Contract No. T200507303.02
Federal Aid Project No. NHS-050(20)
BR 3-156, Indian River Inlet Park Enhancements
Sussex County

Enclosed is Addendum No. 2 for the referenced contract consisting of the following:

1. The date for the receipt of bids has been moved to Tuesday, August 20, 2013 at 2:00 P.M. Local Time.
2. Special Provision 302513, Crushed P.C. Concrete Base Course, has been revised.
3. Special Provision 401510, Porous Flexible Pavement, has been revised.
4. Special Provision 606510, Handrail Type 1, has been revised.
5. Special Provision 614686, Water Service System, has been revised.
6. Ten (10) sheets, Construction Plans, sheets 109-113, 115-118, and 149, revised, to be substituted for the same sheets in the Plan Set.

MATERIAL CALLOUT PLAN

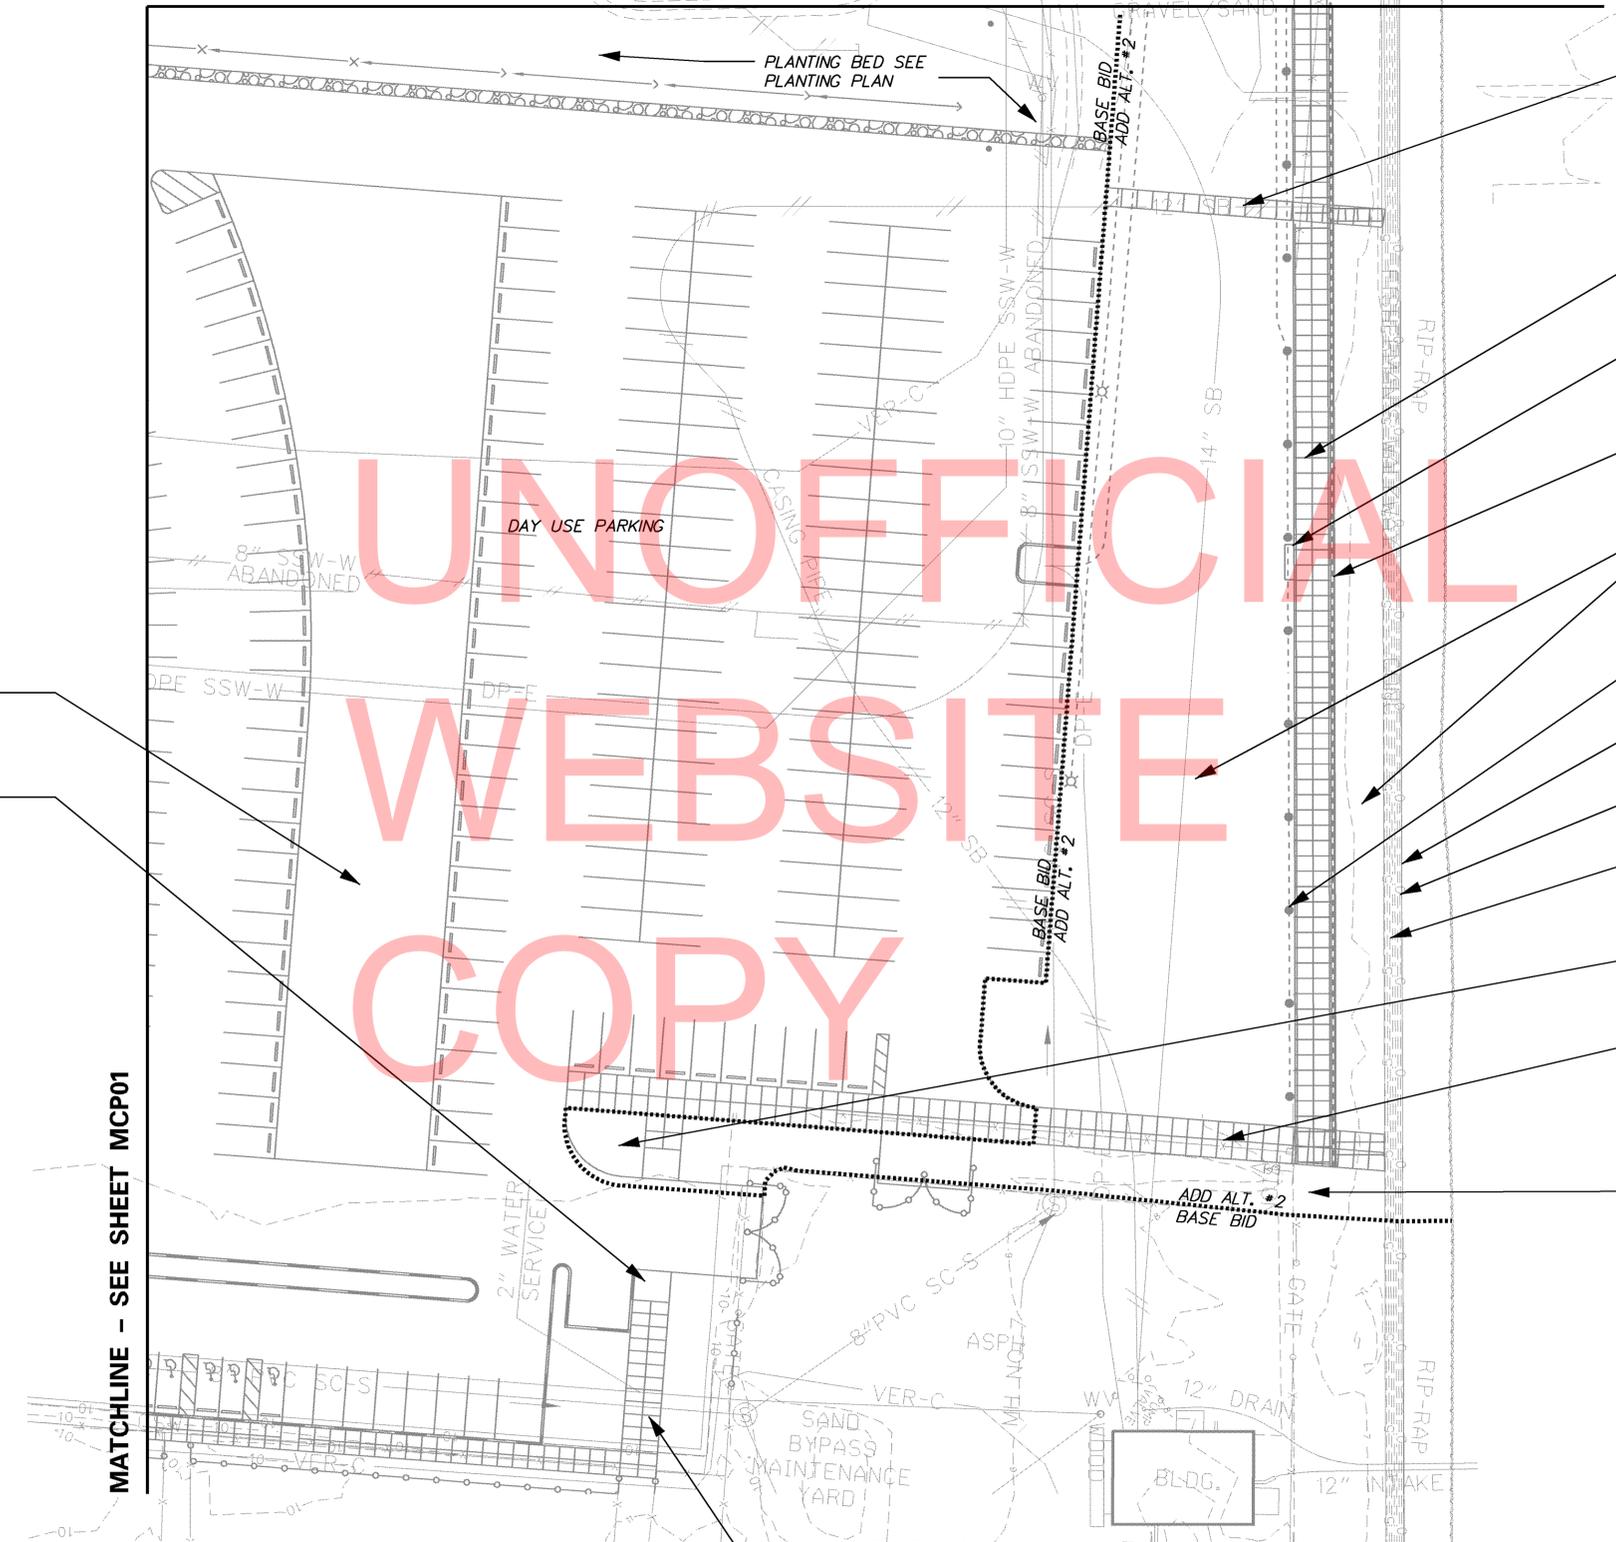
| ADDENDUM NO. 2 REMOVED SIDEWALK CALLOUTS |

| MCP02 |

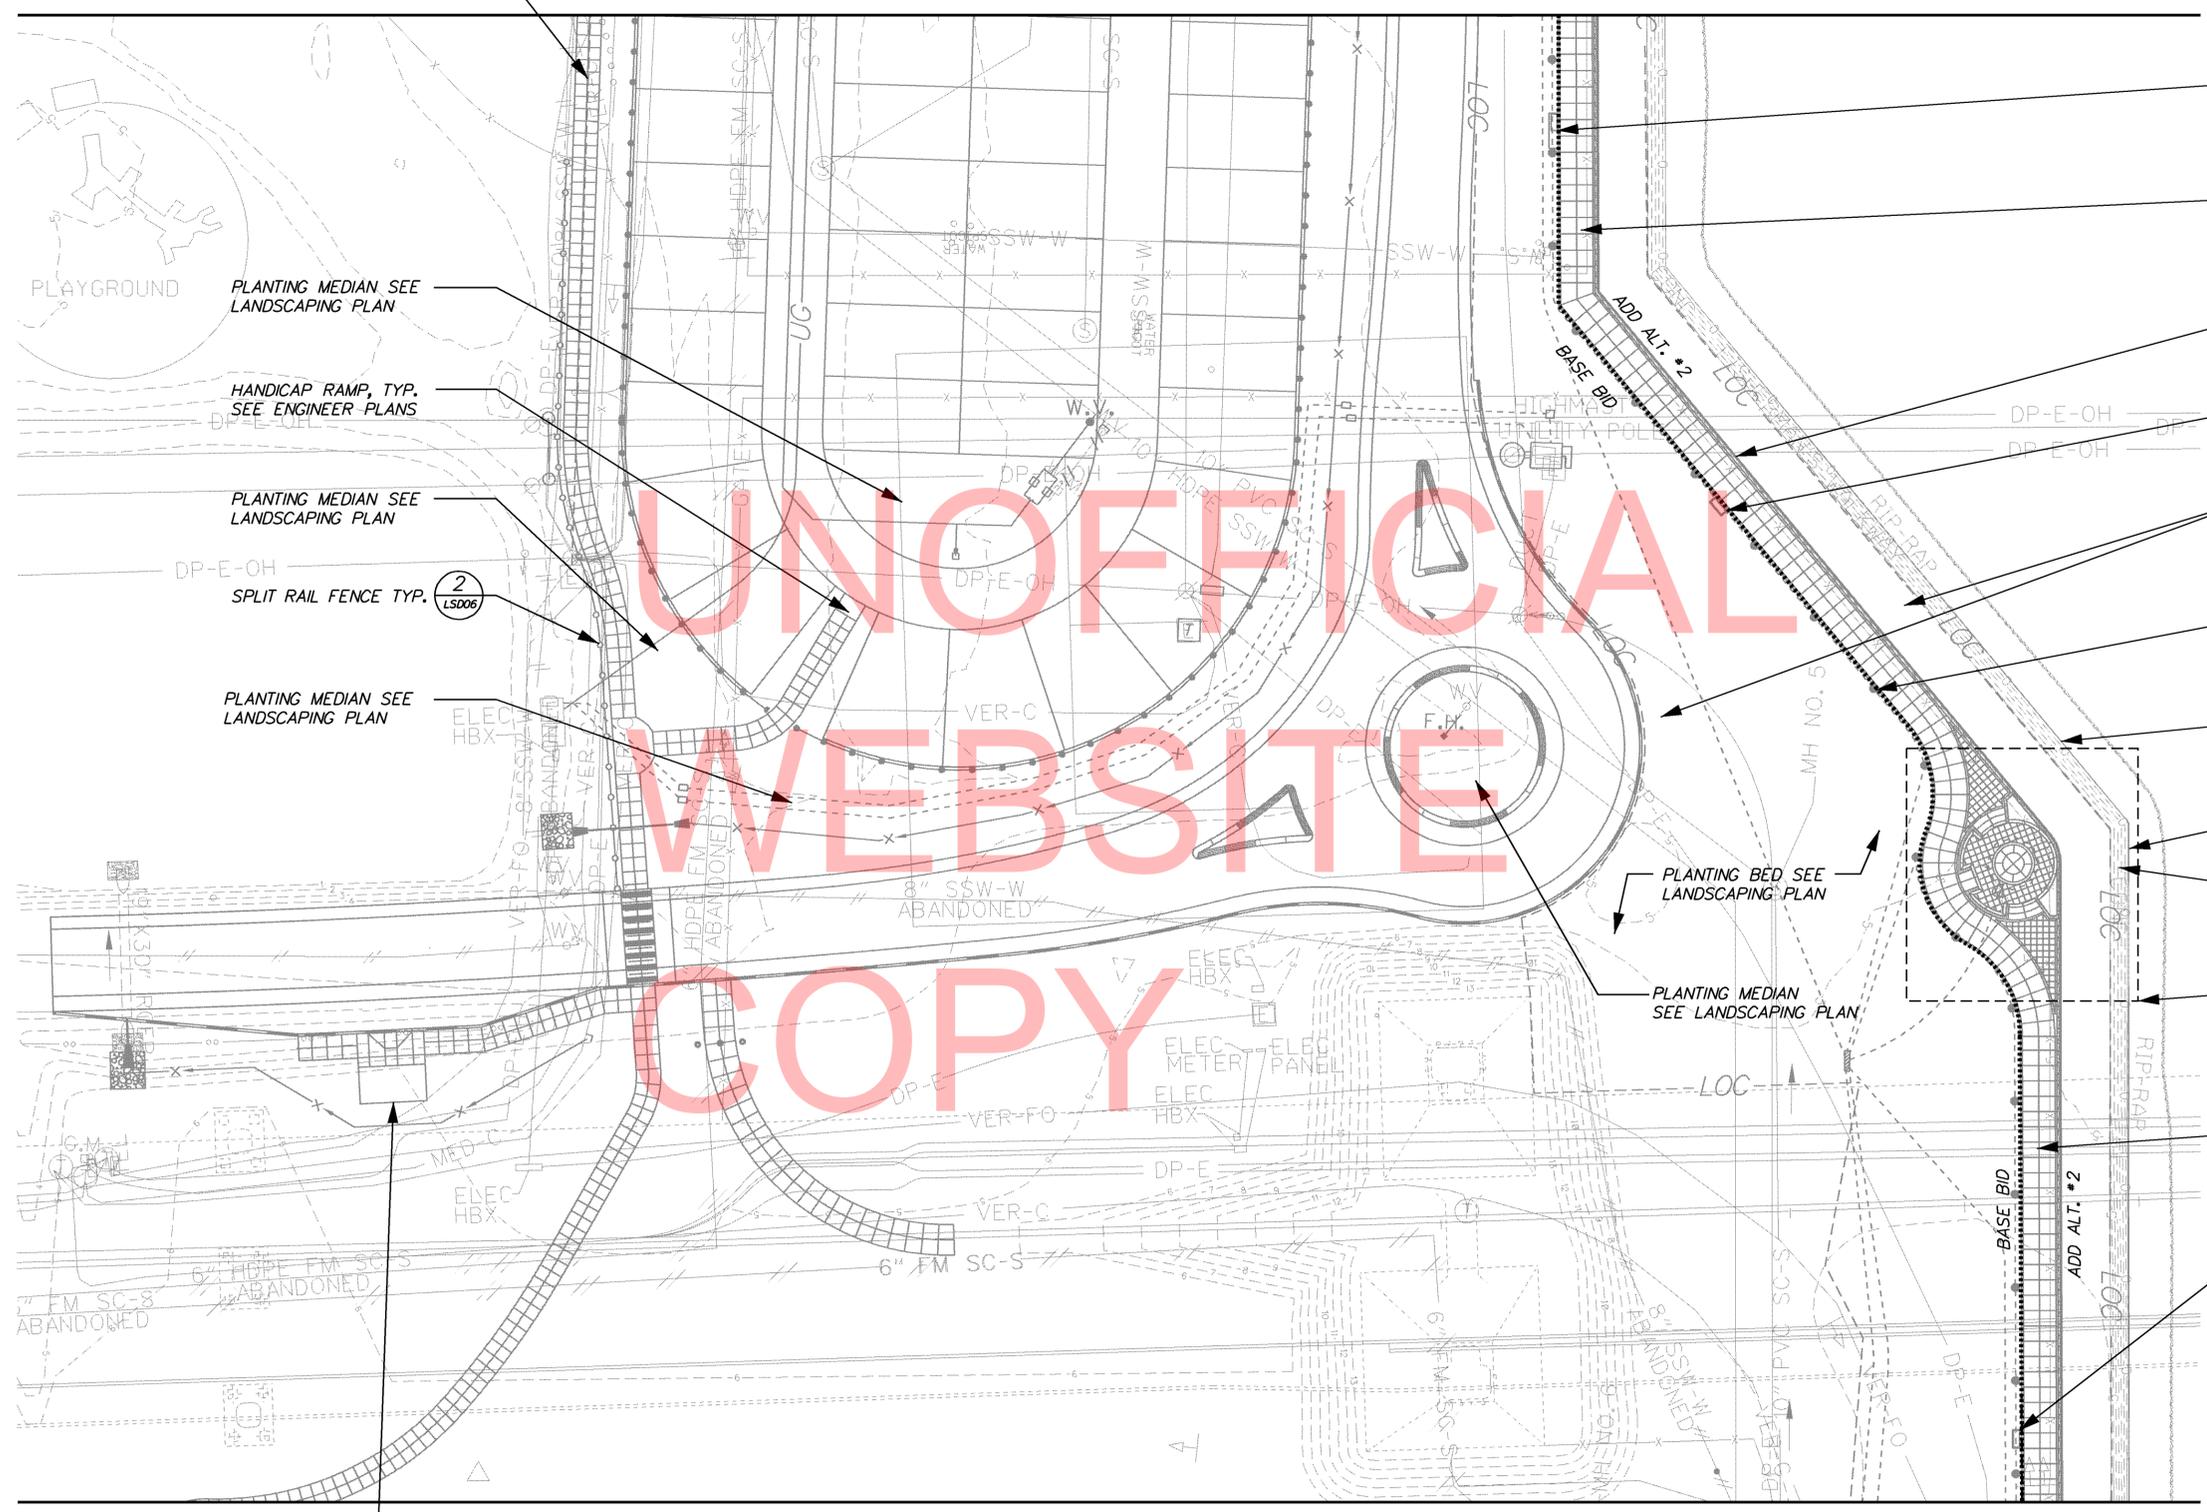
ITEM 705001
P.C.C.
SIDEWALK 4' \triangle 2

NOTE:
 \triangle 2 1. SEE CONSTRUCTION PLANS FOR P.C.C. SIDEWALK LOCATIONS AND TYPE

| ADDENDUM NO. | REMOVED | ADDENDUMS / REVISIONS |
| 2 | SIDEWALK CALLOUTS | |

| SHEET NO. | 111 |

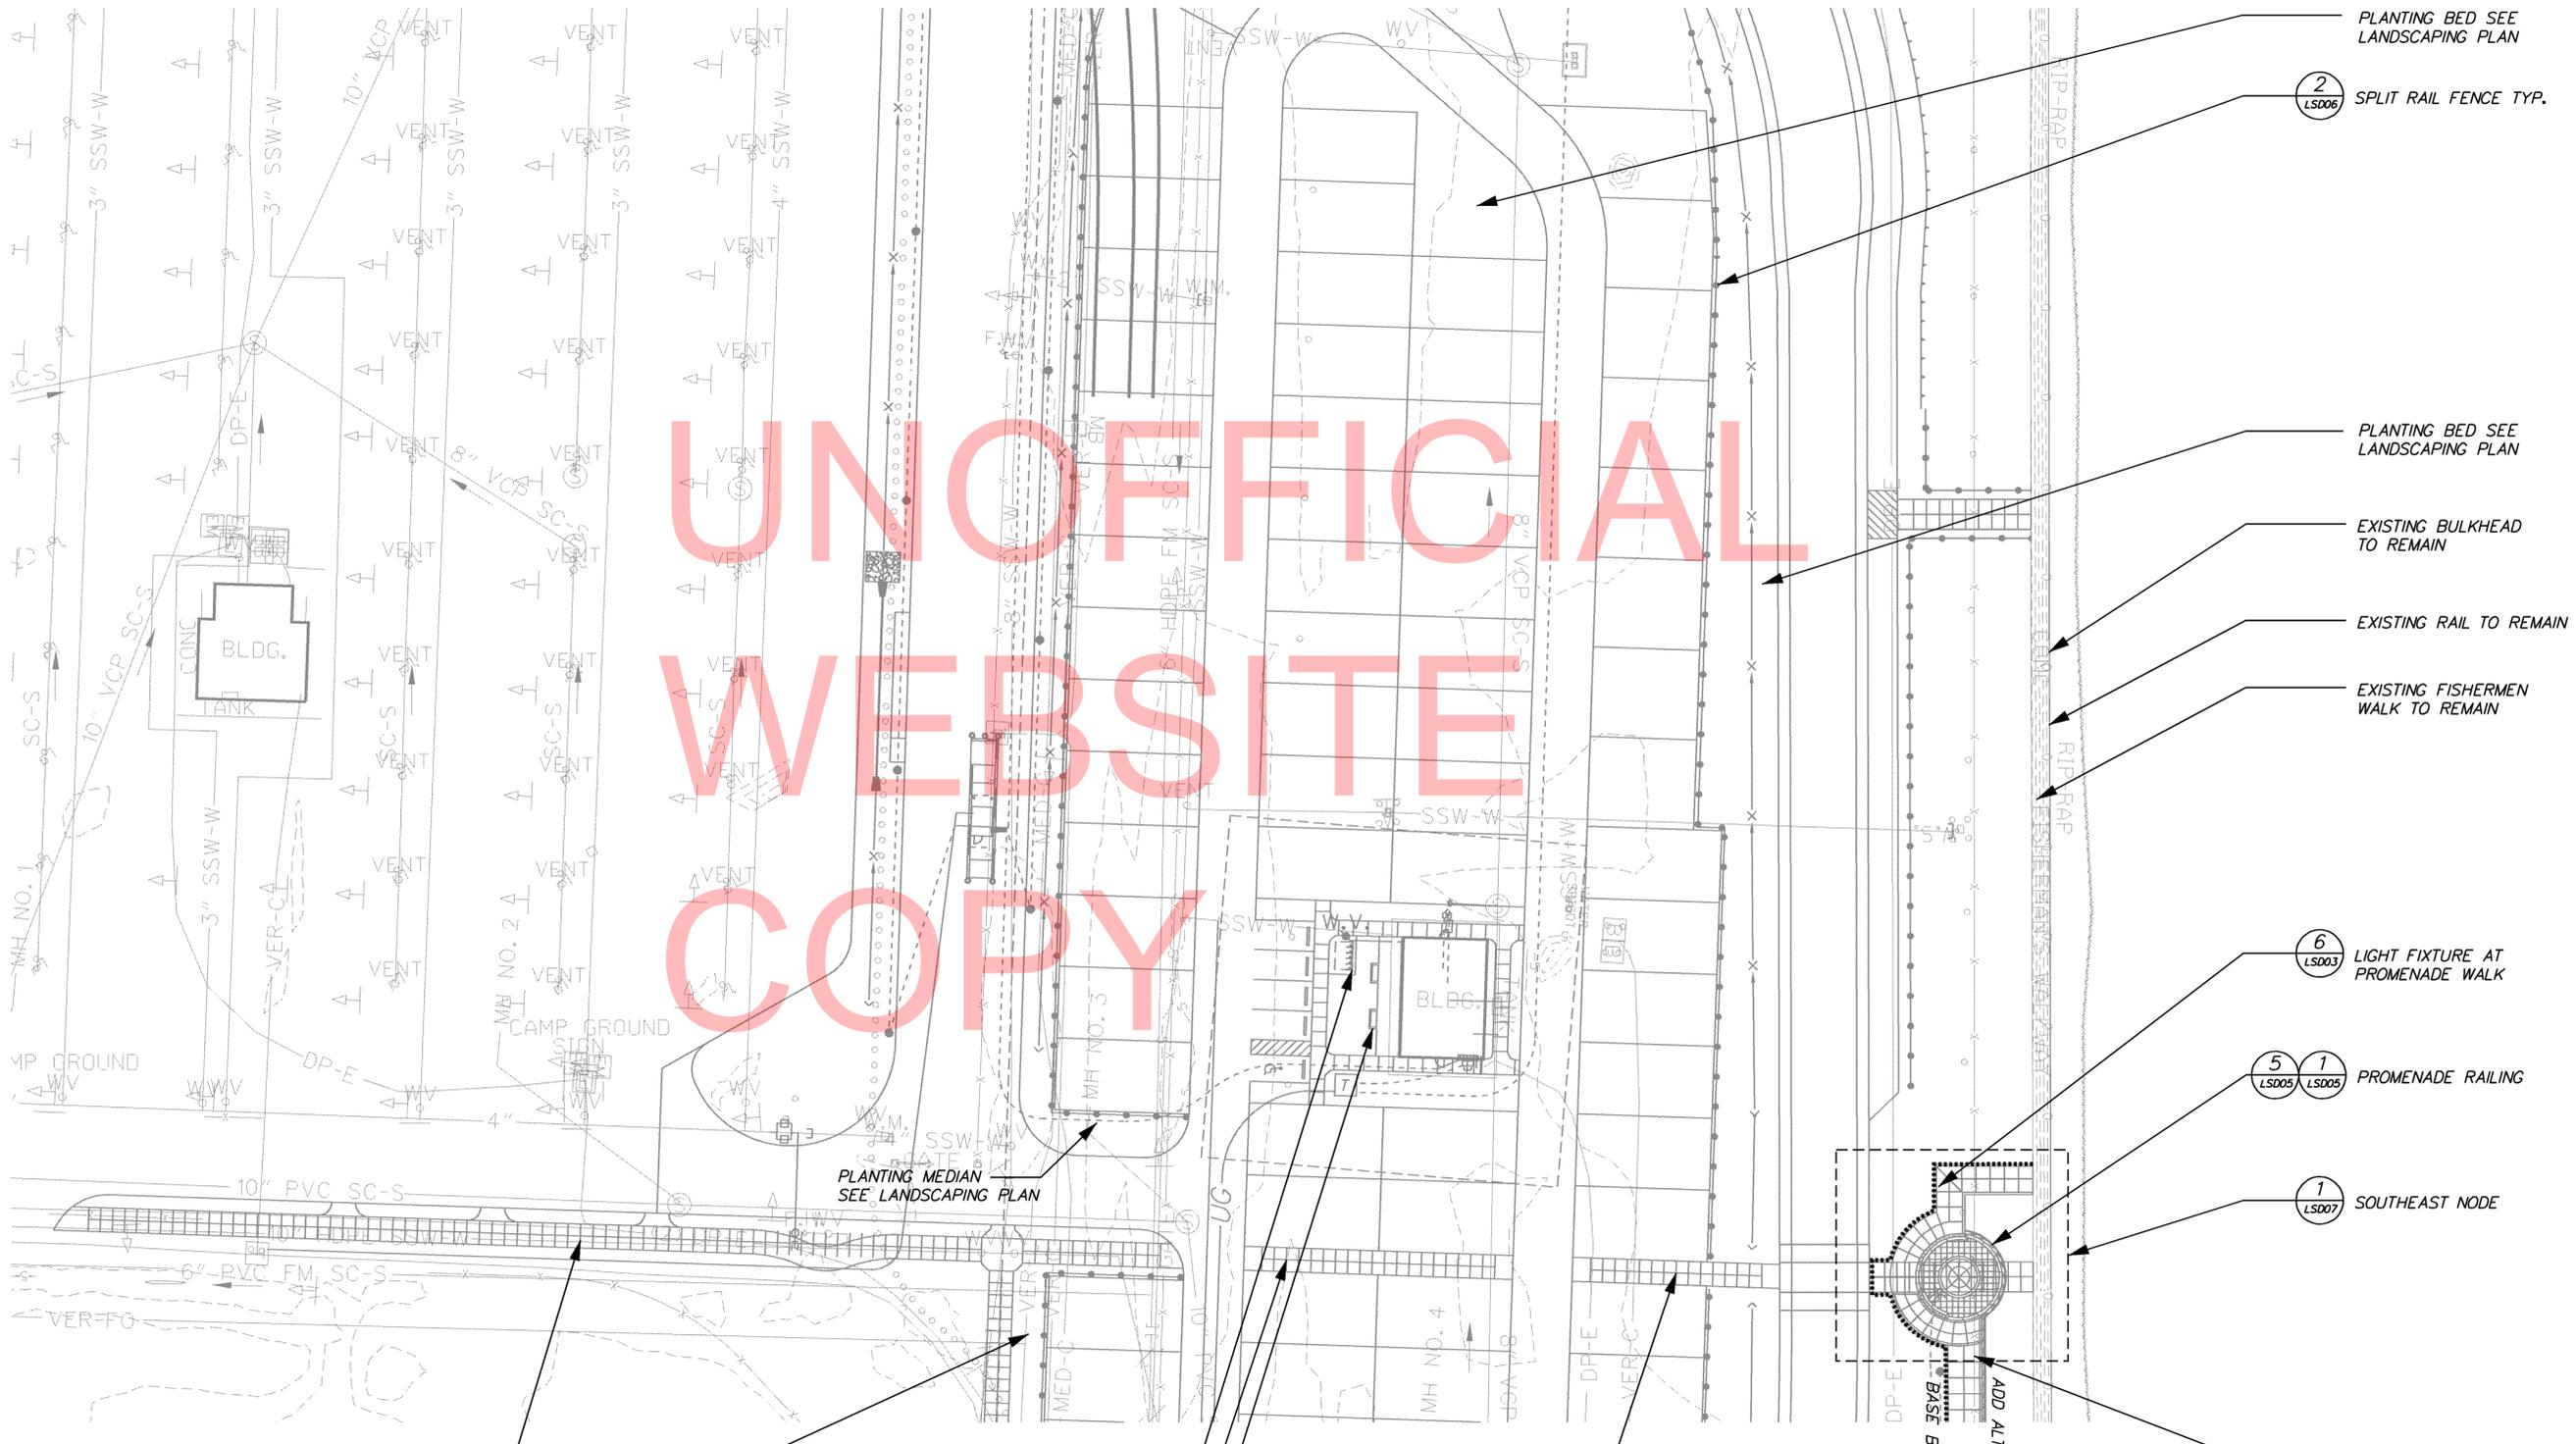
| ADDENDUM NO. | REMOVED | ADDENDUMS / REVISIONS |
| 2 | REMOVED | SIDEWALK CALLOUTS |

| <p>DELAWARE DEPARTMENT OF TRANSPORTATION</p> | ADDENDUM NO. 2 | ADDENDUMS / REVISIONS | <p>AS SHOWN</p> <p>INDIAN RIVER INLET PARK ENHANCEMENTS</p> | CONTRACT T200507303 | BRIDGE NO. X | <p>LANDSCAPING DETAIL</p> | LSD05 | |

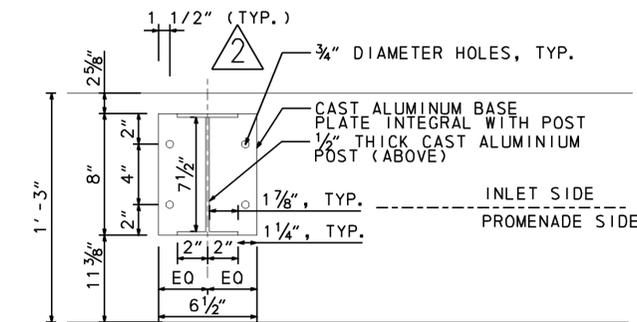
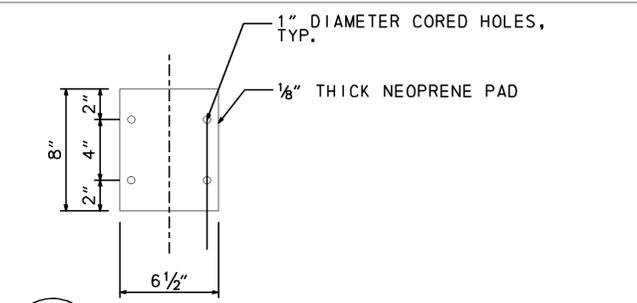
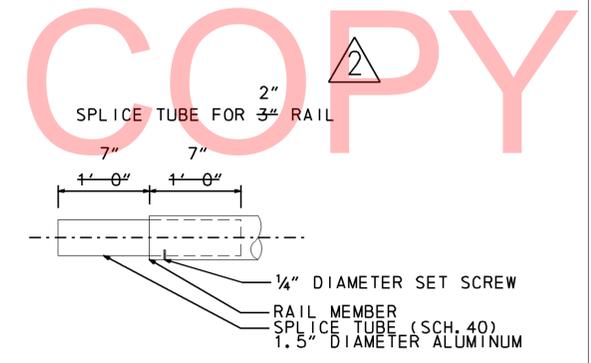
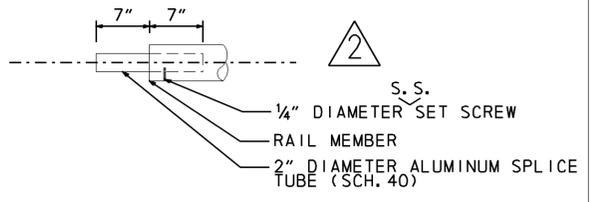
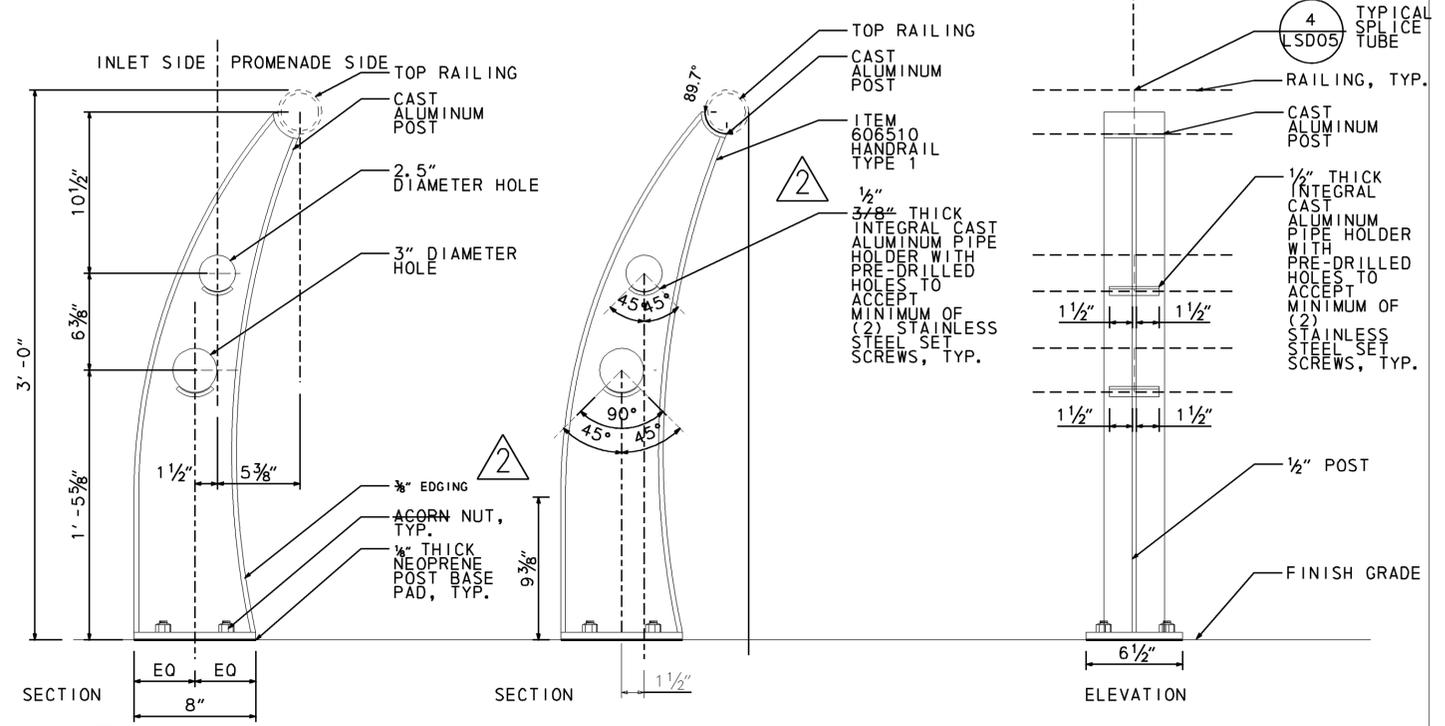
| | REVISED NOTES, DETAILS AND CALLOUTS 07/31/2013 | | | | COUNTY SUSSEX | | DESIGNED BY: RK&K | SHEET NO. 149 |
